Intel[®] 82371EB (PIIX4E)

Specification Update

December 1999

Order Number: **290635-008**

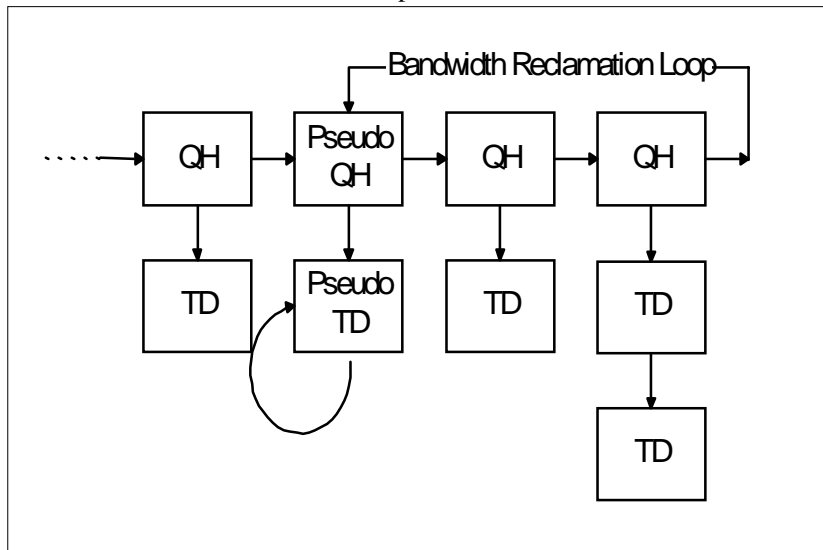
Workaround: When using bandwidth reclamation, the UHCI driver should insert a pseudo queue head with a pseudo transfer descriptor within the bandwidth reclamation loop. The PIIX4 will fetch this queue head and transfer descriptor on every frame, but will not transfer any data and will never be terminated. The following bits must be properly set to implement the workaround:

TD LINK POINTER (DWORD 0: 00-03h)

The Link Pointer (LP=bits [31:4]) must be set to point to itself.

The Depth/Breadth Select bit (Vf=bit 2) must be set to 0 indicating that the PIIX4 should execute breadth first.

The QH/TD Select (Q=bit 1) must be set to 0 indicating it is a TD.

The Terminate bit (T=bit 0) must be set to 0 indicating that the link pointer field is valid.

TD CONTROL AND STATUS (DWORD 1: 04-07h)

The Active status bit (bit 23) must be left unset at 0 indicating that the PIIX4 should not execute this TD.

QUEUE HEAD LINK POINTER (DWORD 0: 00-03h)

The Queue Head Link Pointer (QHLP=bits [31:4]) must be set to point to the pseudo TD.

The QH/TD Select (Q=bit 1) must be set to 1 indicating it is a QH.

The Terminate bit (T=bit 0) must be set to 0 indicating that the link pointer field points to a valid TD.
